SKETCH PLAT **DEPARTMENT OF** **TRANSPORTATION** **3RD ADDITION**

DEPARTMENT OF TRANSPORTATION
AND CITY OF WICHITA

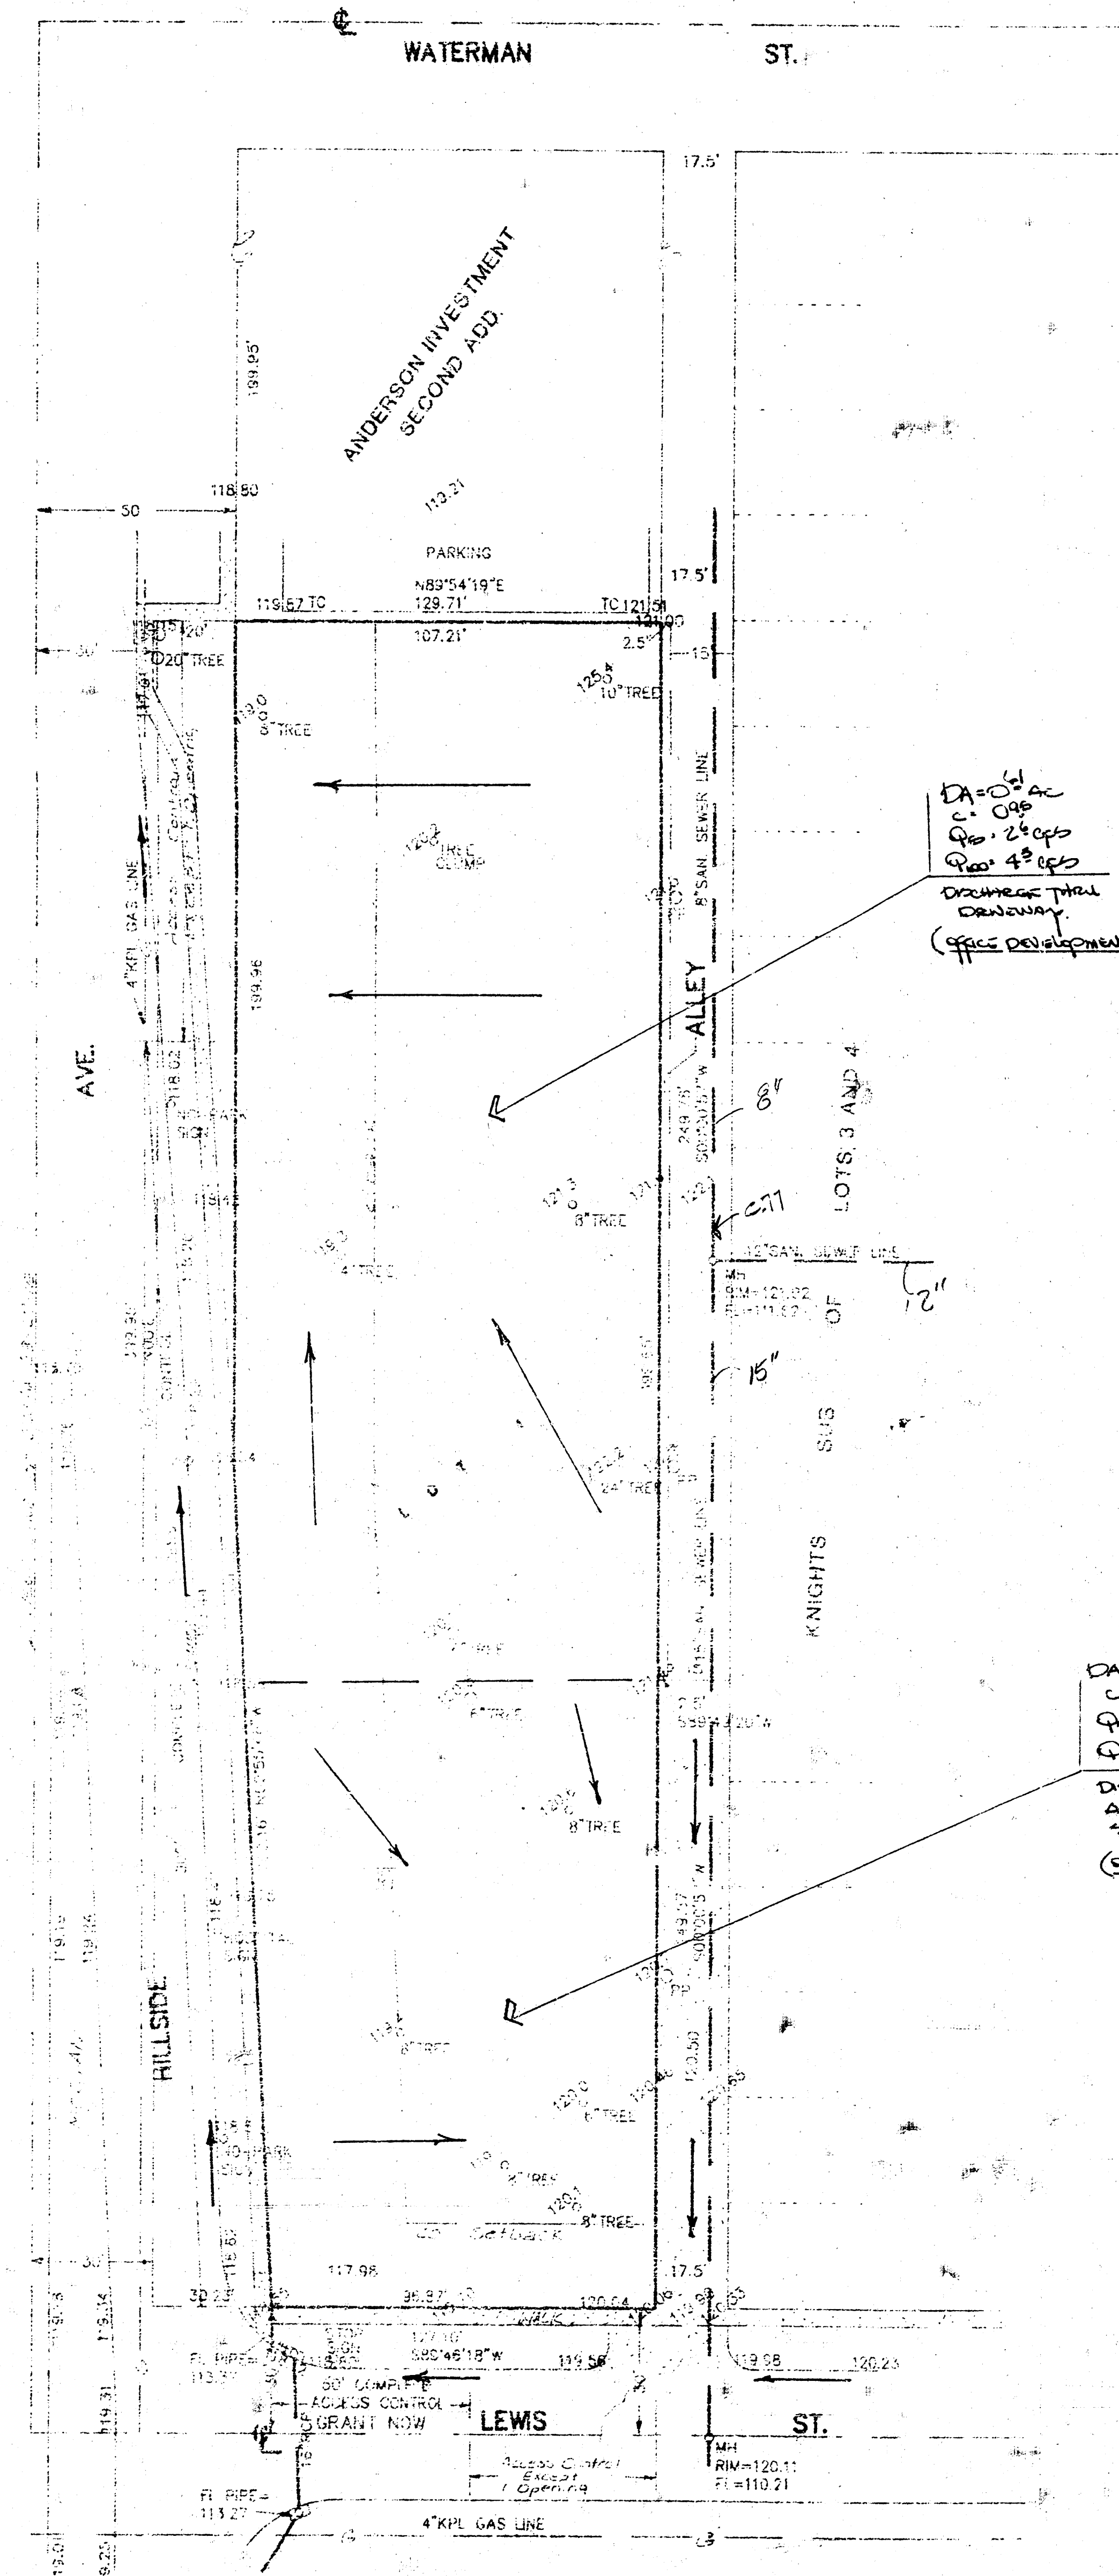
Prove existing storm sewer can take all water & tell what existing runoff to to SS is.
And prove won't flood street
Paved Alley? Brent
